ZÁVAZNÝ SERVISNÍ BULETIN / MANDATORY SERVICE BULLETIN

TÝKÁ SE / CLARIFICATIONS: Replacing the brake disc top hat washers in the main landing gear hub.

DATUM VYDÁNÍ / DATE OF NOTICE: 5.2.2015

ČÍSLO BULETINU / NOTICE ID: 2.S.SI ST.2015

Removal of the original top hat washers

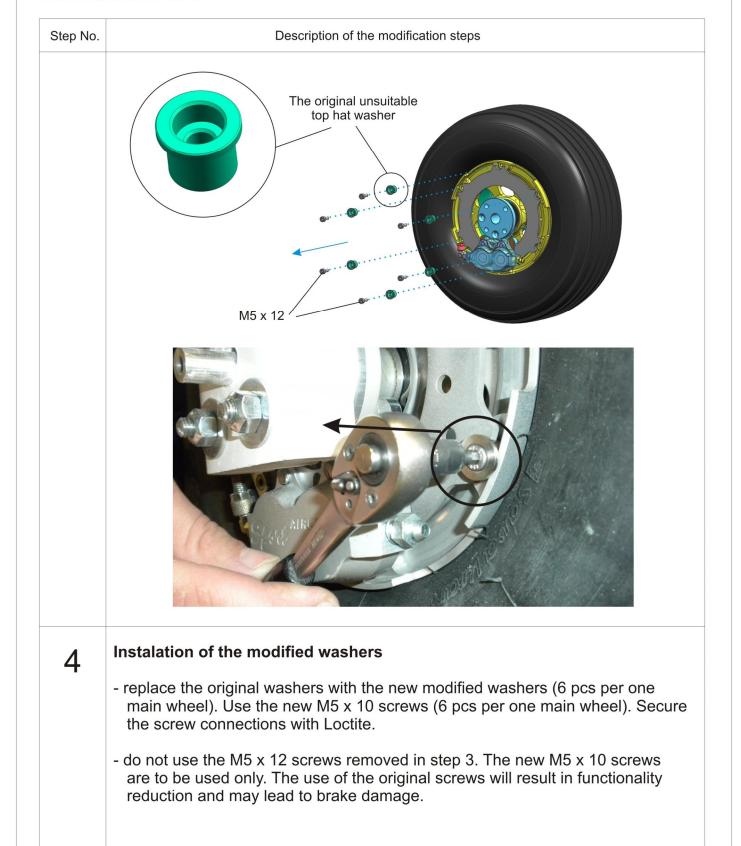
- remove the top hat washers from the main wheel hub. The washers are attached to the hub by M5 x 12 screws. There are 6 washers total attached to the main wheel that need to be removed

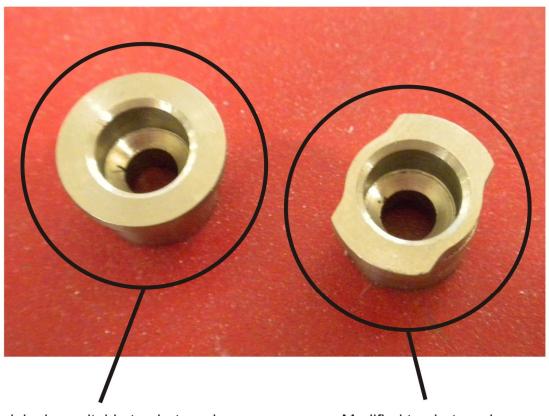
The original unsuitable top hat washer (necessary to replace with the modified option)

Modified top hat washer

As a solution to this condition, the TL-ULTRALIGHT suggests the replacement of the six original top hat washers on each wheel with the new version of top hat washers. At the same time, it is also necessary to replace the M5x12 screws for the shorter M5x10 screws, with which the washers are attached to the wheel hub. This modification will allow for a better leeway space between the critical parts of the wheel, preventing their contact prior to reaching the permitted brake pad wear limit.
